Subject: Land Stability of the Six Mile Ponds Area

To: William H. Boley, Forest Engineer

The purpose of the examination was to assess the stability of the Six Mile Ponds area and to identify possible stability problems that may be associated with the reconstruction of the Upper Six Mile Ponds dam.

MAP 1

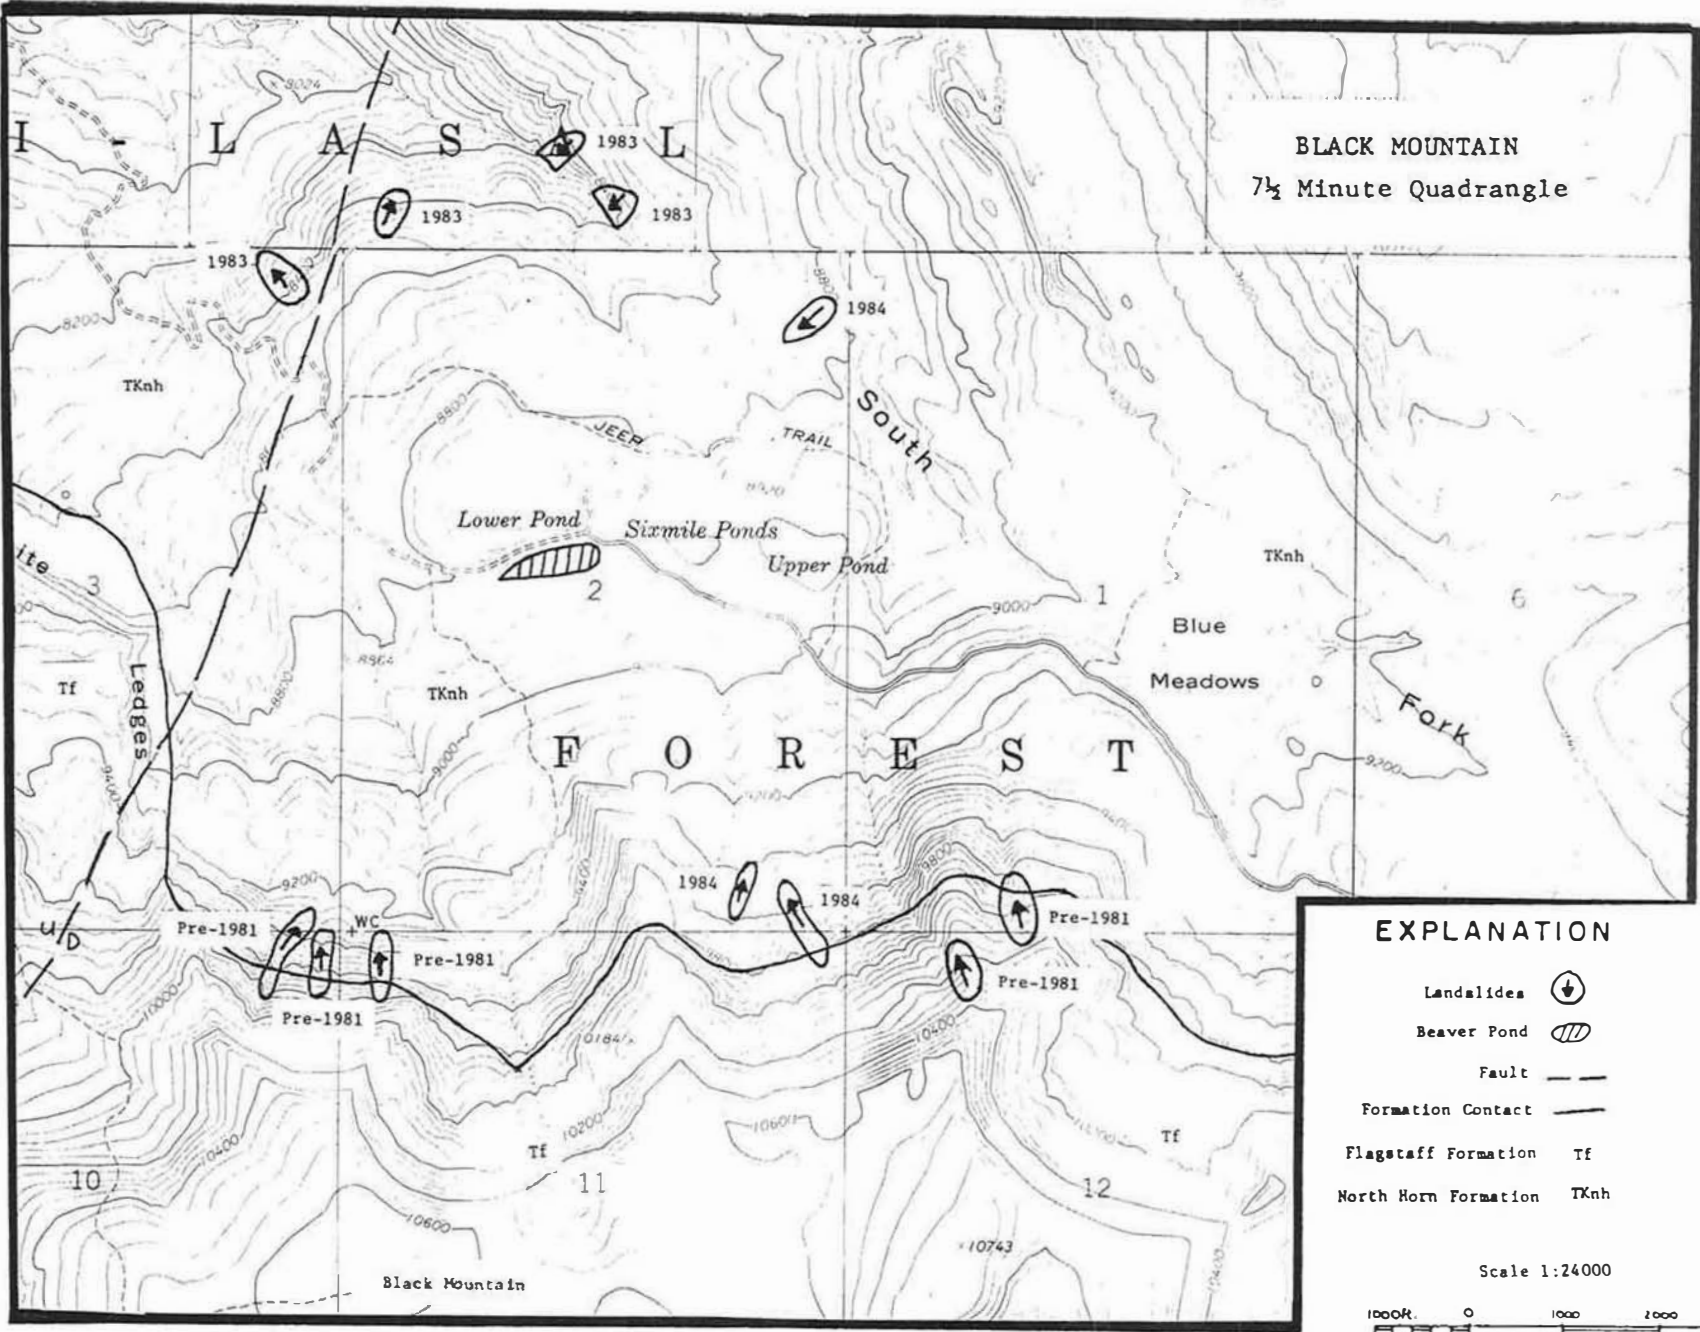
The subject area is located in the NE $\frac{1}{4}$ of Section 2, T19S, R3E (map 1). The dam associated with the Upper Pond failed and was subsequently breached in 1975. Reconstruction of the dam is now being evaluated for recreational purposes.

There are debris flows on the steep slopes of Black Mountain. These slides are small, shallow, and elongated in shape. Some rock fall from the Flagstaff Limestone is involved in the slides originating further up slope. These slides mobilize soil, vegetation, and unconsolidated material, and deposit the debris on the more gently sloped base of the mountain. If these slides or new ones were to move, the energy from their movements would most likely be dissipated once reaching the gentler slope near the base of the mountains. Many of these debris flows are older than 1981 and a few were formed in the spring of 1984.

There are small earth slumps on the sides of the South Fork of Six Mile Canyon. These slides move along a concave surface of rupture with the main body of unconsolidated material tilted backward toward the slope. Undercutting of the slope by the stream initiated these earth slumps. Most of these slides formed in the spring of 1983 and one in the spring of 1984.

There is a large beaver pond about 500 feet south of the lower pond. The immediate area around the pond is saturated. The beavers are actively working on the dam. Removal of the beaver dam would decrease the degree of saturation of the unconsolidated material and reduce the possibility of a slope failure occurring in the area. The beavers may also enlarge their pond and cause water to flood over the road.

The Six Mile Ponds area appears to be stable at this time. The existing landslides in the vicinity do not threaten the stability of the ponds. Removal of the beavers, beaver dam, and associated pond would decrease possible future stability problems. No cracks or other surface expressions of slope failure were found near the Upper Pond dam. Reconstruction of the Upper Pond dam should not be affected by the landslides.
